CITY OF ALBUQUERQUE

March 24, 2023

Re: Veterans Integration Center
2701 Mulberry St. SE
Traffic Circulation Layout
Architect's Stamp XX-XX-XX (M15-D054)

REVISION	DATE
RBA ARCHITECTURE, PC ARCHITECTURE PLANNING DESIGN 1000 Alameda Ave. SW Albuquerque, NM 87102 www.rbaarch.com	
DATE	02-28-2023
SHEET NUMBER	AS-2.00

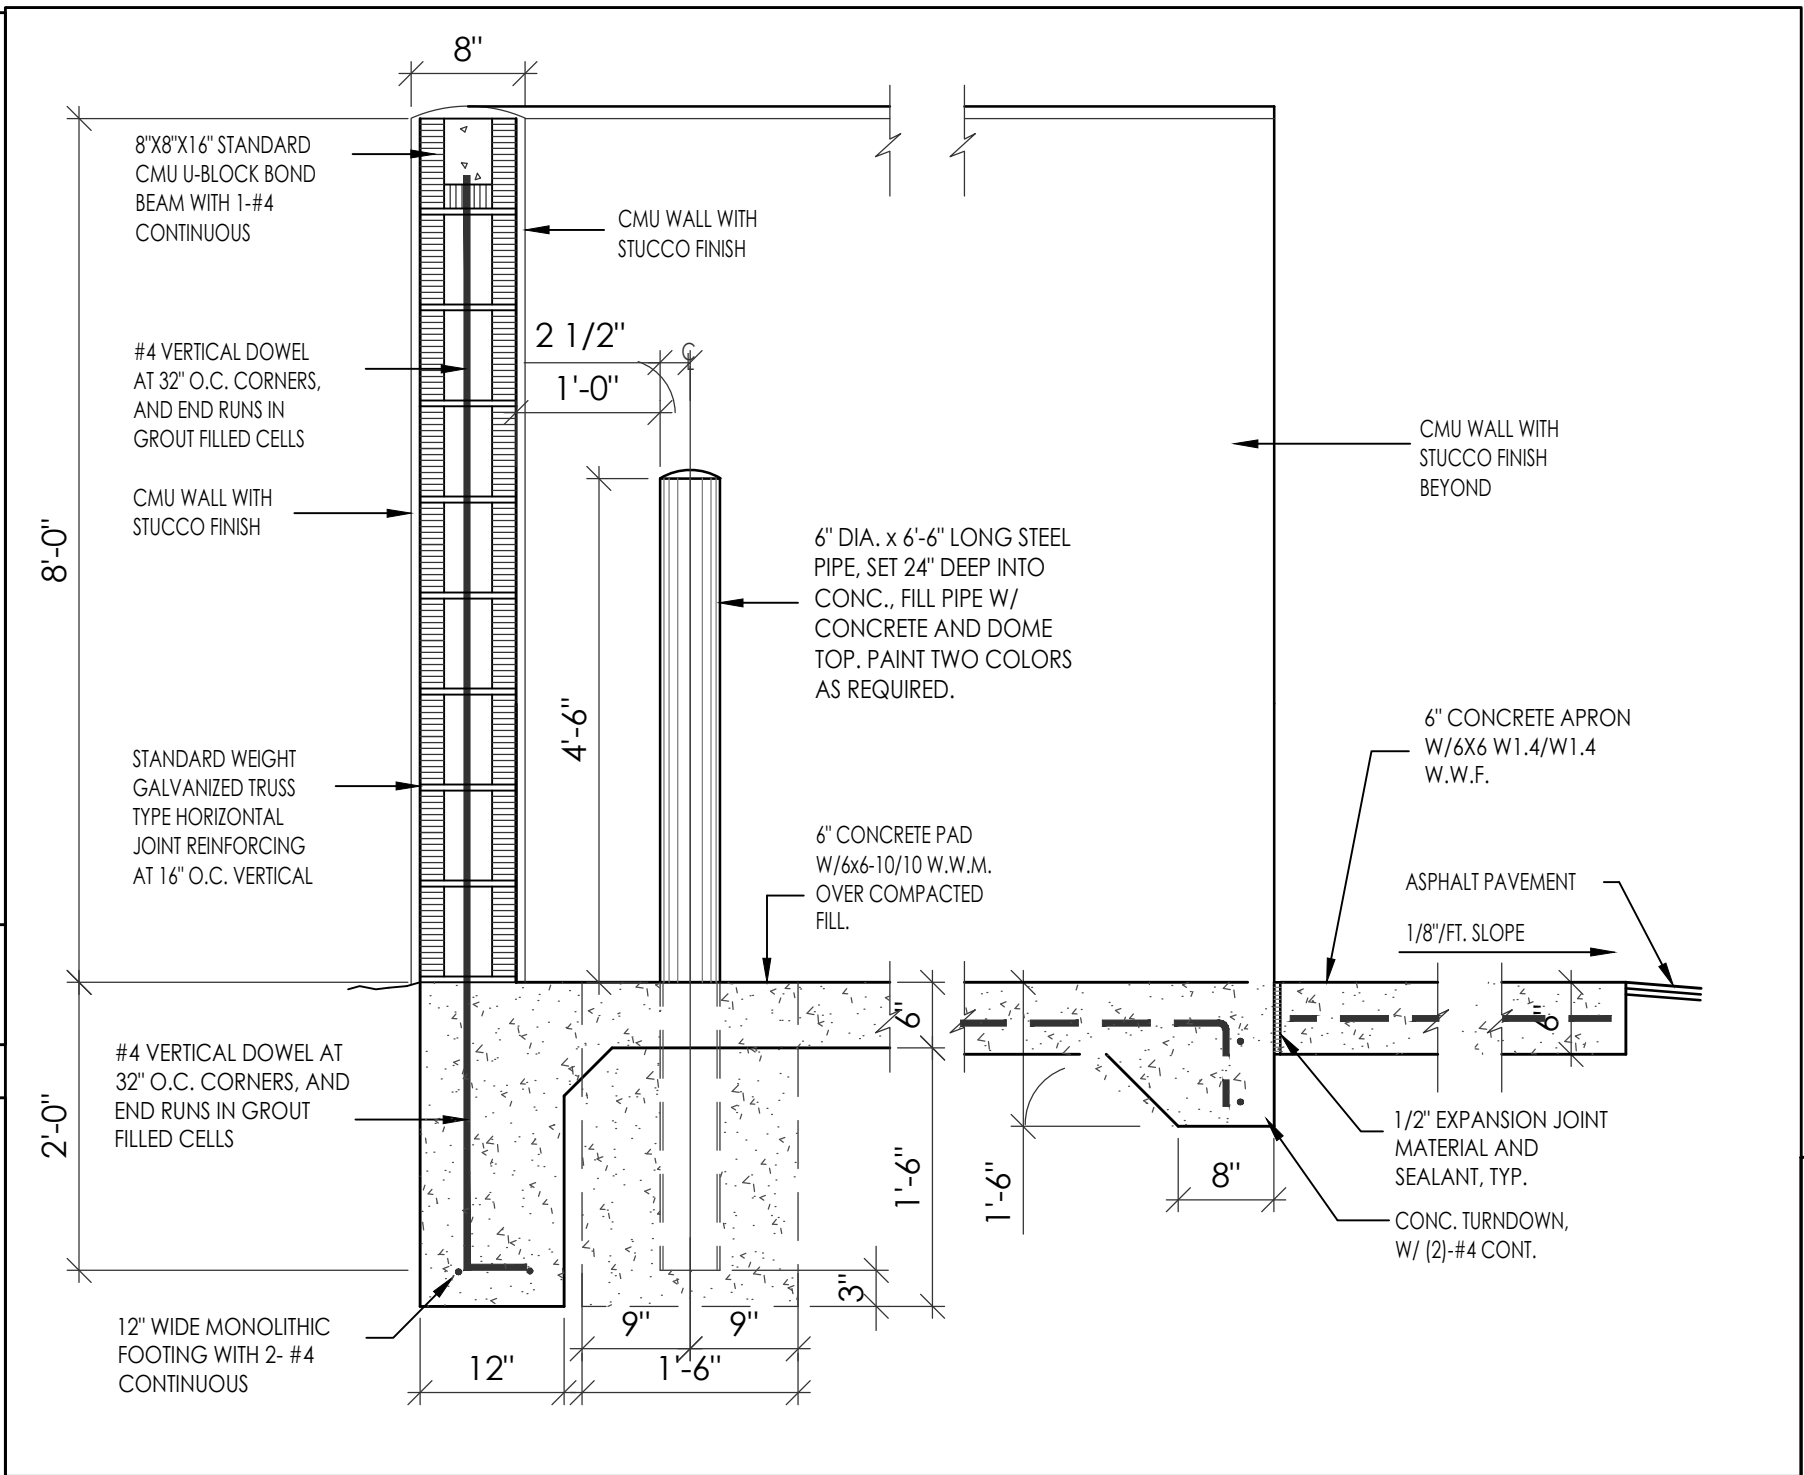
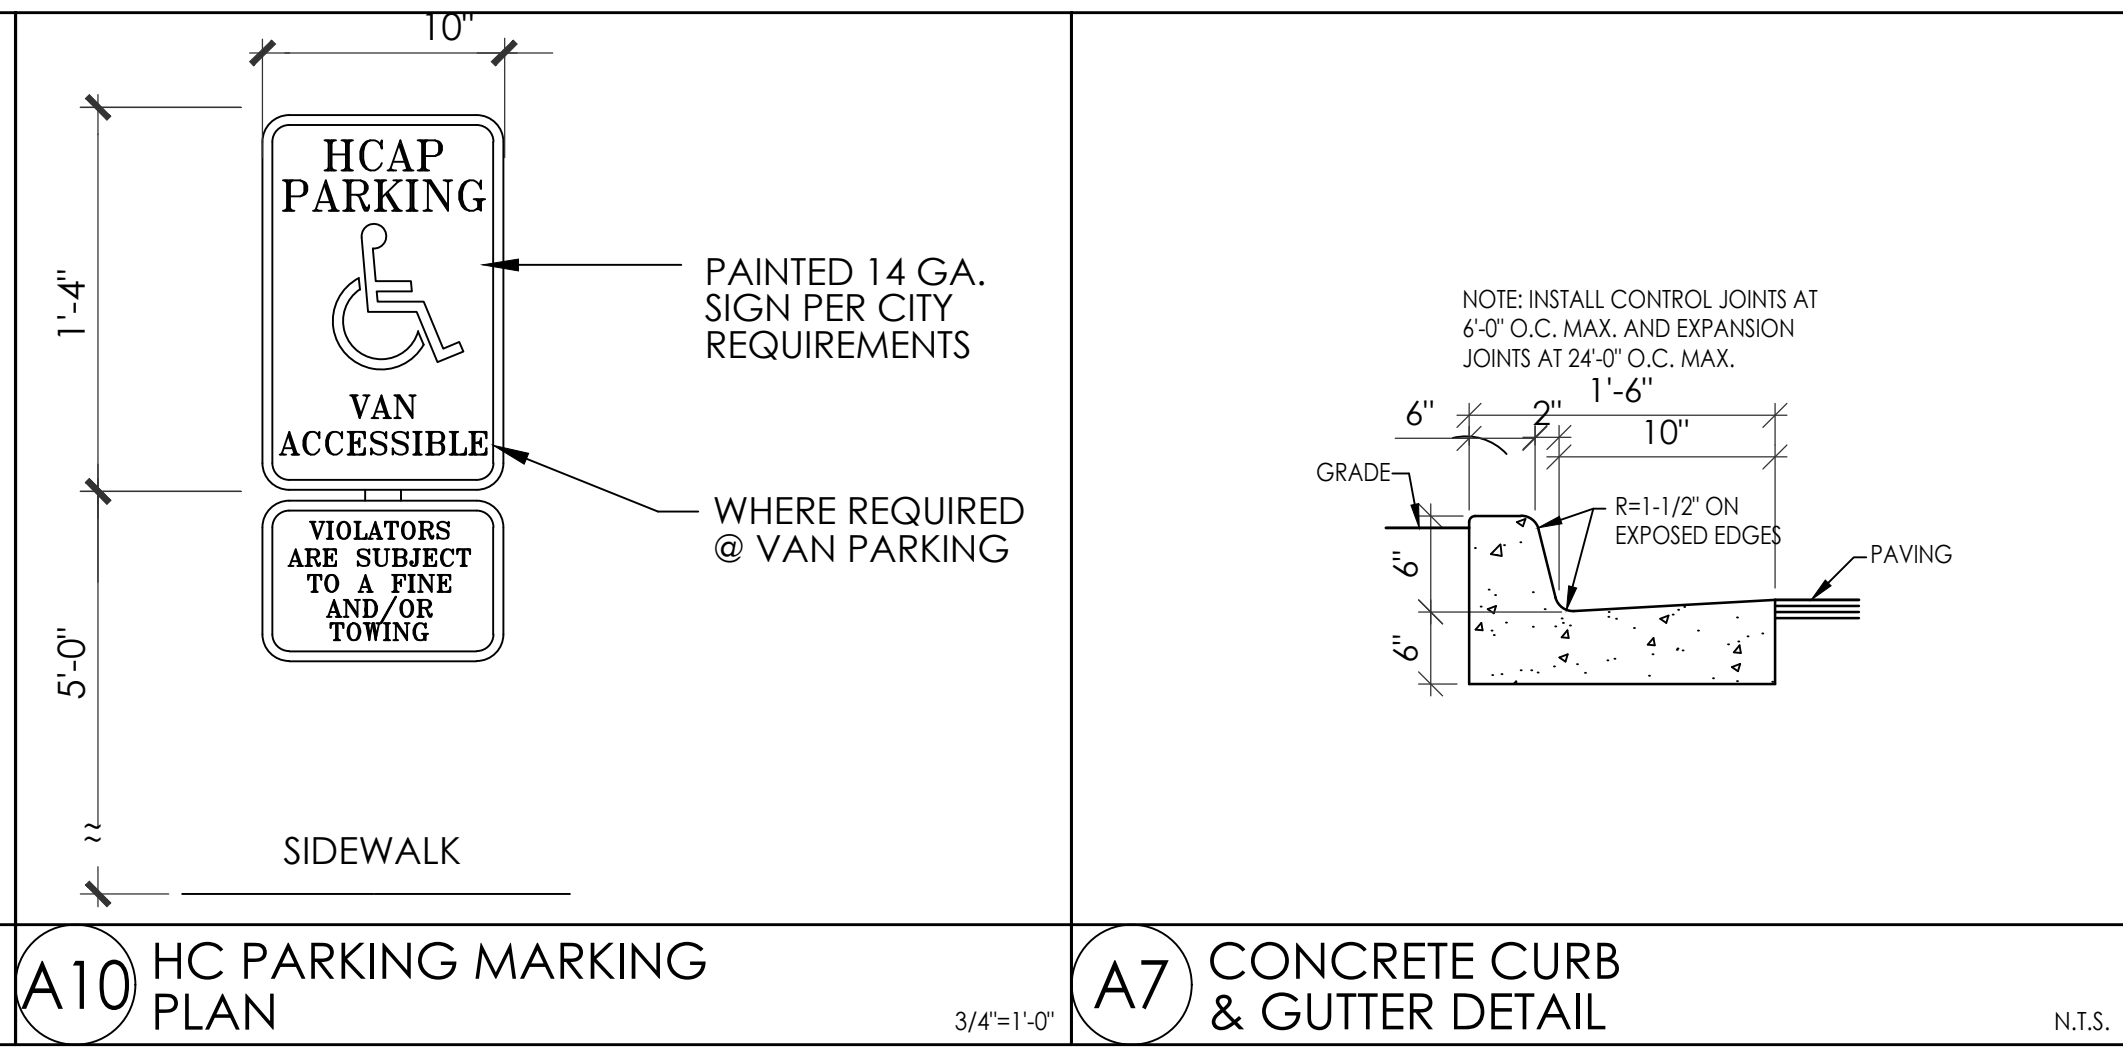
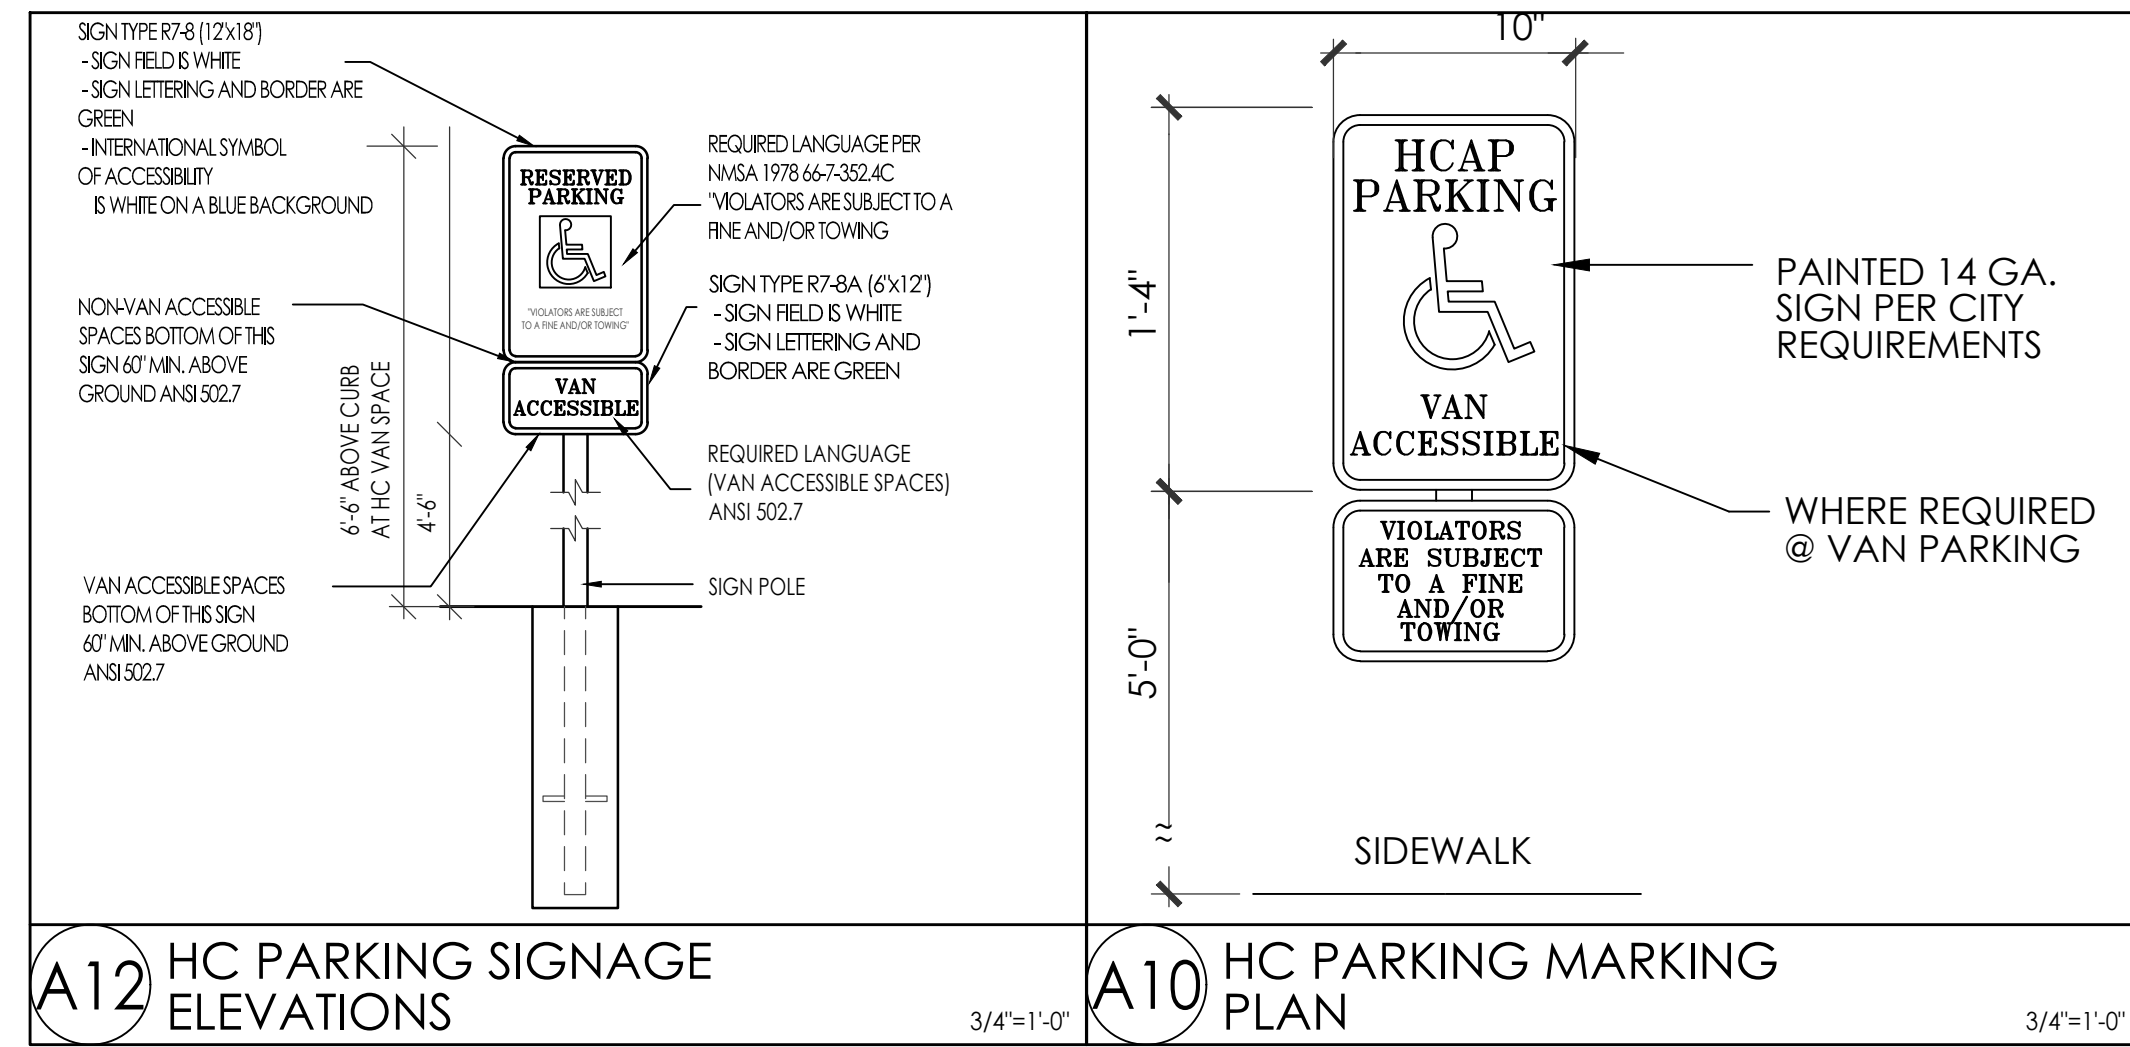
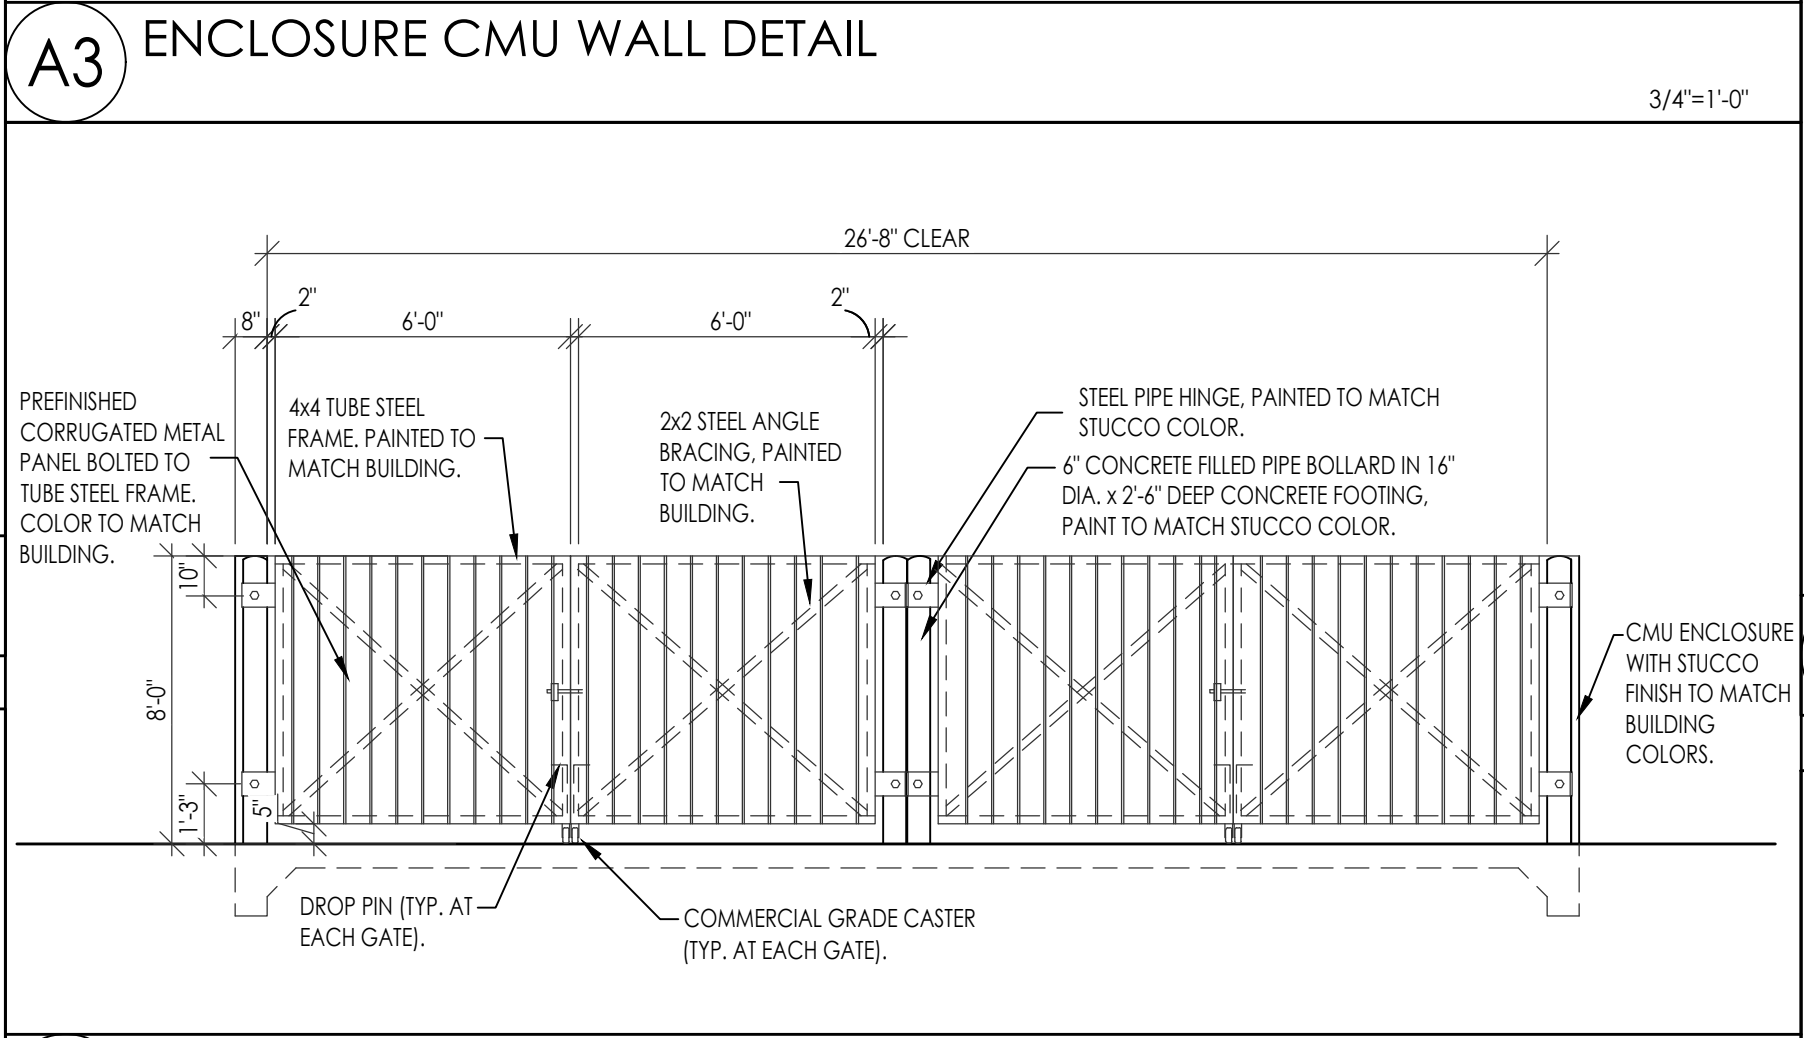
9. Please show on the site plan the word "NO PARKING" on each ADA aisle.
10. Provide a copy of Fire Marshal approval.
11. On the details sheet, please provide Transportation details only. We stamp and approve transportation details only.
